KINGSTON FOSSIL PLANT - ANNUAL INSPECTION OF WASTE DISPOSAL AREAS

KINGSTON FOSSIL PLANT (KIF)—ANNUAL ASH POND DIKE
STABILITY INSPECTION

ANNUAL ASH POND DIKE
STABILITY INSPECTION

**KINGSTON FOSSIL PLANT
NPDES PERMIT NO. TN0005452
ANNUAL ASH POND DIKE STABILITY INSPECTION
2001**

Photo 1—Looking northeast: Coal yard drainage basin

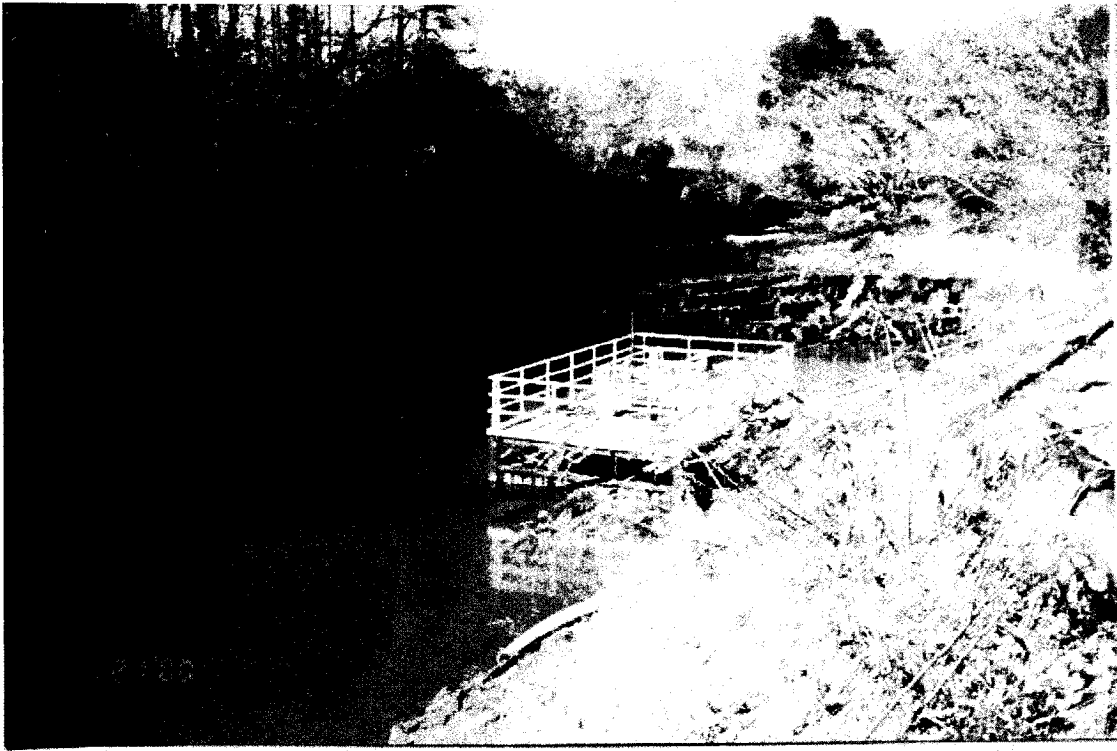
The coal yard drainage basin is located at the southwest corner of the coal pile. This basin was excavated below grade; therefore, there are no exterior dikes. All discharge from this basin is pumped into the fly ash discharge ditch which flows to the active ash disposal area. At the time of inspection, water in the pond was at a low level. The slopes appeared to be in satisfactory condition. (photo #1) Currently, there is a project underway to excavate more sediment from this pond.
